Groundwater Transfer Review Summary Form

Transfer/PA # T- 14011

Application: T-14011

Applicant Name: J.R. Simplot: J.R.S. Properties III, LLP

T-14011 - From Wells

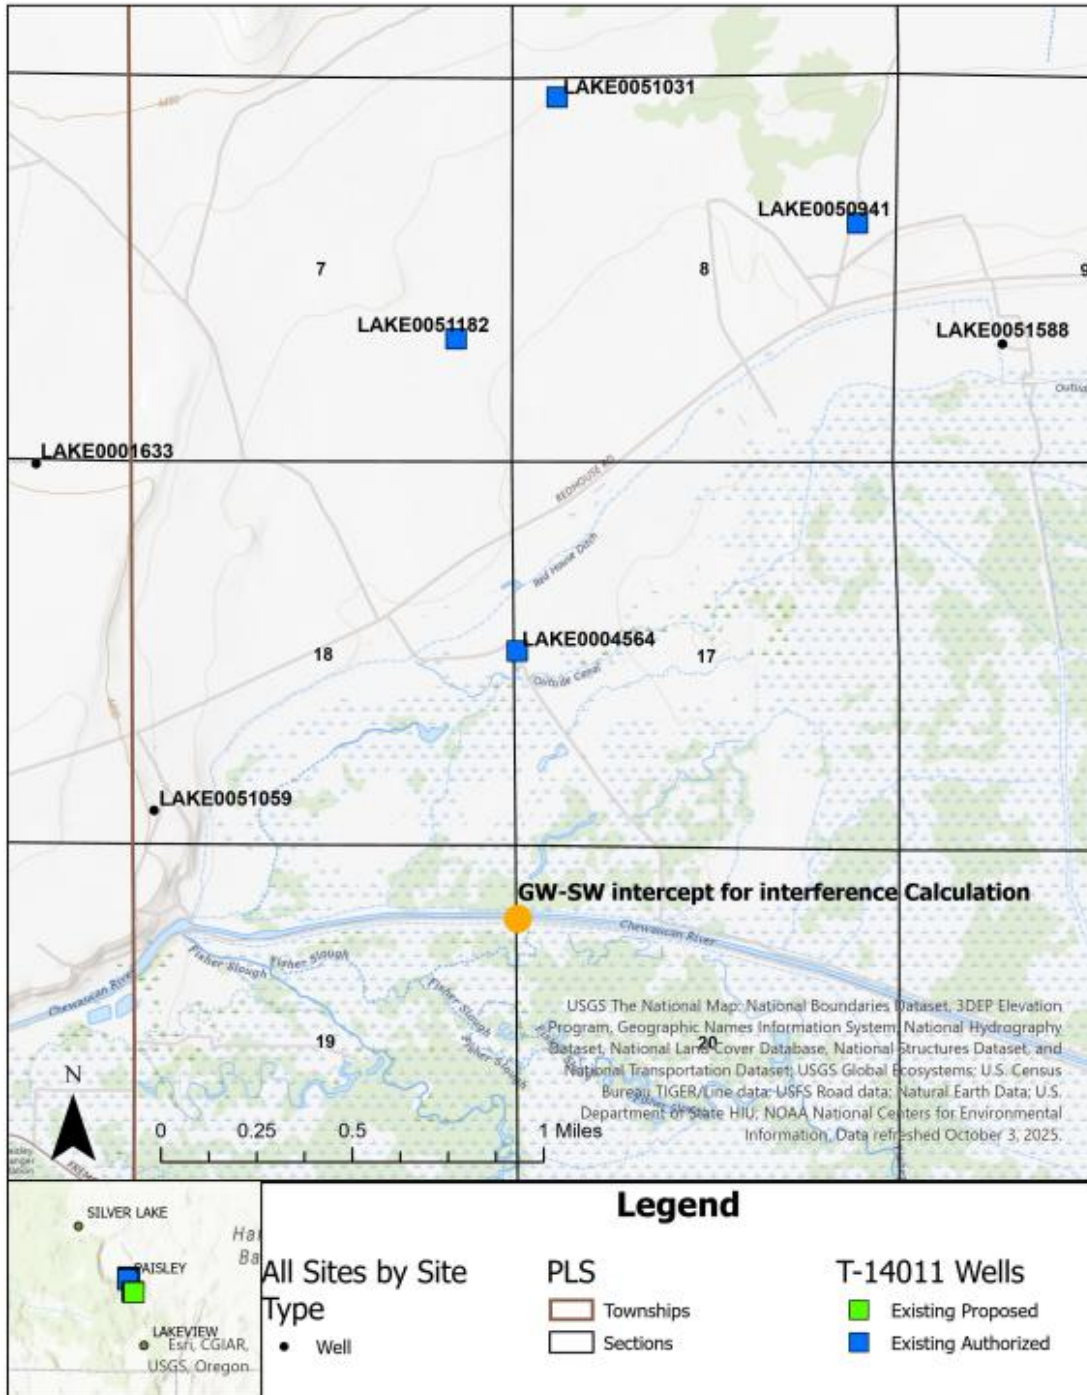
☒ Yes ☐ No Comments: The proposed change will move groundwater pumping about 6.8 to 8.8 mile south from the north side of Upper Chewaucan Marsh to the south side of Upper Chewaucan Marsh (see attached maps). The proposed change will move groundwater pumping closer to a different set of groundwater right wells (see attached maps).

Area Hydrographs**Reference Level Discussion Hydrographs**

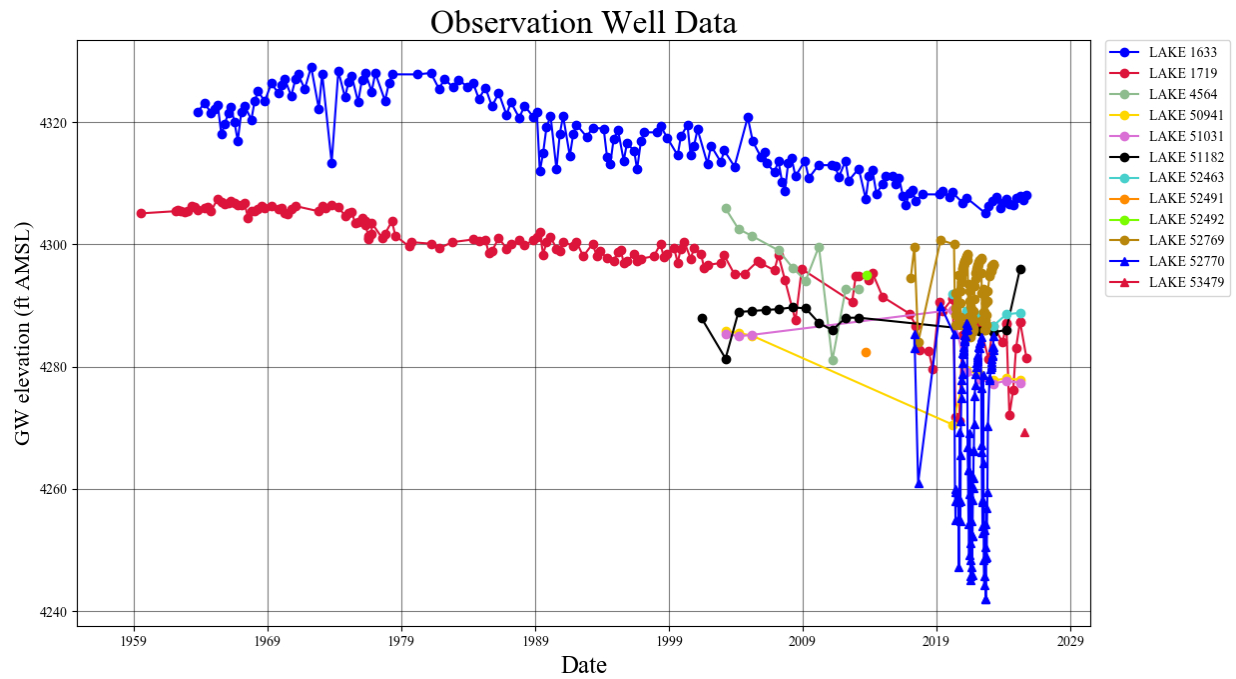
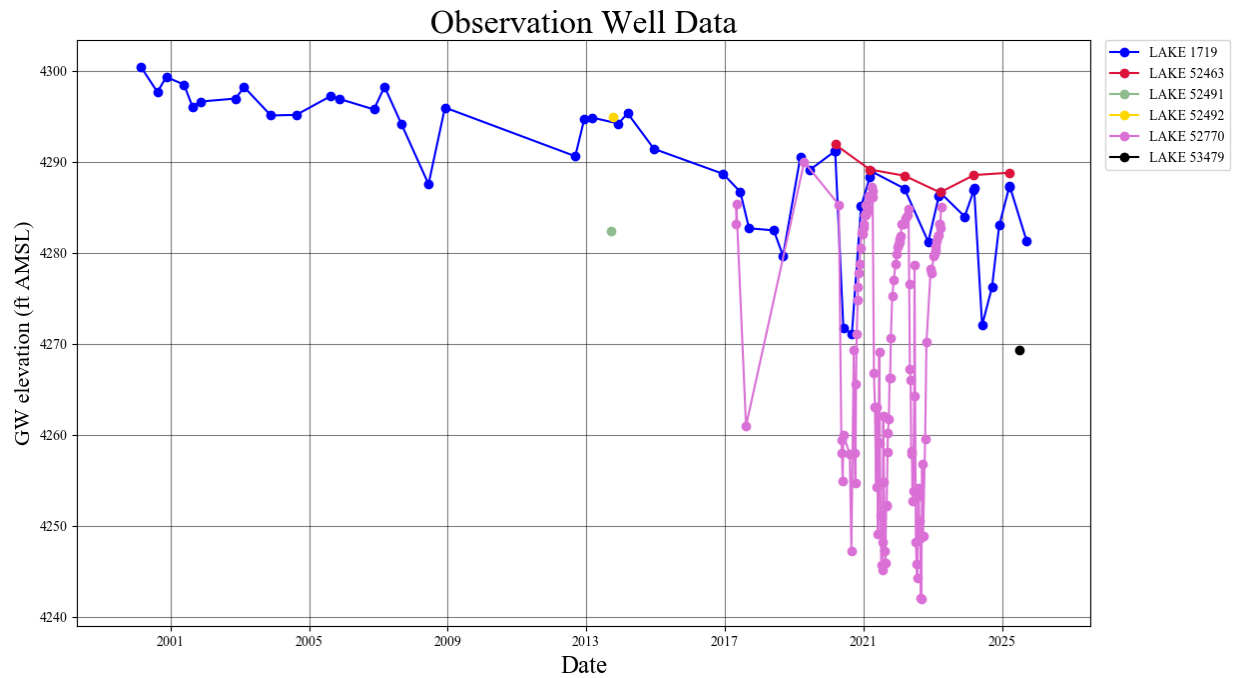
Additionally, the proposed change moves groundwater pumping into a vicinity that appears to be experiencing a groundwater level decline since 2005 (see attached hydrographs). The groundwater level at well LAKE 1719 is relatively stable, near 4302 feet elevation amsl from 1960 to the mid-1970s, a decline of about 5.5 feet from the mid-1970s to early 1980s to a new equilibrium of about 4297 feet elevation amsl that is close to the Chewaucan River stage near the Narrows (relatively steady from about 1980 to 2005), and an ongoing decline since 2005, possibly taking the groundwater level below the river bottom. The groundwater level decline in the 1970s and after 2010 may correspond to increased groundwater development in the area.

The applicant has submitted 2017 to 2023 data (see hydrographs) for wells LAKE 52769 [60 feet total depth], and LAKE 52770 [1,100 feet total depth], and LAKE 52463 [410 feet total depth]. The data can be interpreted as showing an annual decline like LAKE 1719 which has experienced a total groundwater level decline of 20.2 feet over the period of record.

LAKE 52491 and LAKE 52492 were installed in 2013, however, March groundwater levels have not been collected despite these wells being listed under temporary transfer T-13524. No groundwater levels are available from LAKE 53479 other than at time of well completion in July of 2025 Given the lack of water level data for these wells, it is not possible to make well specific evaluations regarding extrapolating reference levels. However, given that data available from LAKE 1719, LAKE 52770 and LAKE 52463 suggest similar groundwater levels and trends despite differing construction, it is likely that the other “From” POAs listed on this transfer would also show similar groundwater levels and trends (See attached “Reference Level Discussion Hydrographs”).

POA #	Well Log ID	2003 Water Level Reference Elevation (amsl)	Land Surface Elevation at Well Location (amsl)	Permit Condition Reference Level (bls)
7R	Not constructed	4295	4315	20
8	LAKE 52491	4295	4320	25
9	LAKE 52592	4295	4329	34
10	LAKE 52770	4295	4329	34
11	LAKE 53479	4295	4319	24
